Spring Hill Planning Commission Voting Meeting

TO: Spring Hill Planning Commission
FROM: Gilles Morin, Senior Planner
MEETING: December 8, 2025
SUBJECT: PDF 1969-2025 (Legacy Pointe, Heavy Retail)

PDF 1969-2025: Submitted by Manhard Consulting for **Legacy Pointe, Heavy Retail**. The property is located to the east of The Crossings Shopping Center, and to the north of Saturn Parkway, on Crossing Circle. It is zoned Planned Development (PD) with a base zoning of C-5 and is approximately 44.8 acres.

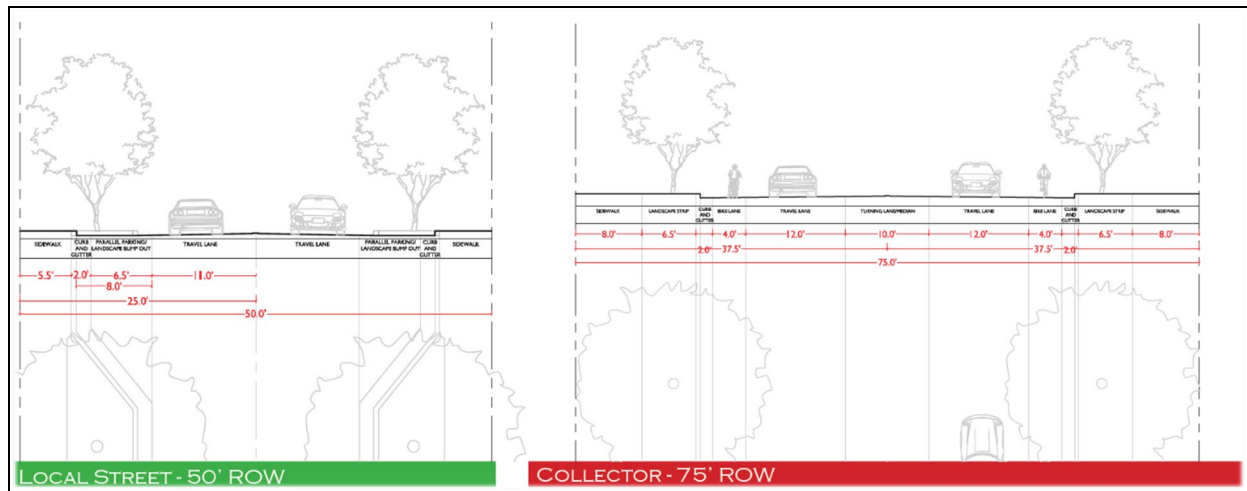
- b. Per UDC, Article 16, Section C, Table 16-2, a westbound right-turn deceleration lane with a minimum storage of 75' should be provided.
- 3) Legacy Point Trail and Project Access #3

The access should be constructed with one lane for entering traffic and one lane for existing with a minimum of 75' of storage.
- 4) Legacy Point

The applicant provided revisions that addressed the conclusions of the Traffic Access Study.
